Interactive comment on "Coupled eco-hydrology and biogeochemistry algorithms enable simulation of water table depth effects on boreal peatland net CO₂ exchange" by Mohammad Mezbahuddin et al.

Mohammad Mezbahuddin et al.

Fig. 1.

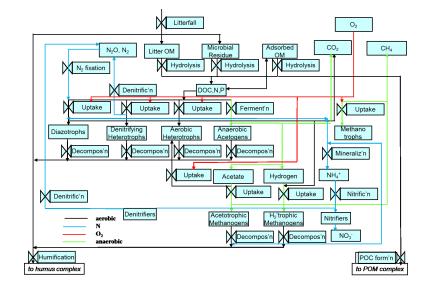
Referee's comment: My only major suggestion in that a visualization of the interactions at different water table levels might help to summarize the results in a way that's easier for readers to grasp. Sections 2.1.2 and 2.1.3 lay out a lot of competing responses to water table depth (oxygen availability, decomposition, root growth, nitrogen availability, : : :). While the description is pretty clear, I think a visualization would be really helpful. This could be as simple as a table or text box with columns for vascular plants, non-vascular plants, aerobic microbes, etc and rows for different hydrological regimes with the key processes affecting each ecosystem component.

Authors' response: A flow chart will be added to depict the key biogeochemical and physiological responses to different water regimes (e.g. aerobic vs. anaerobic) that were modelled in ecosys and described in section 2.1. An example of the flow chart is attached herewith as figure 1.
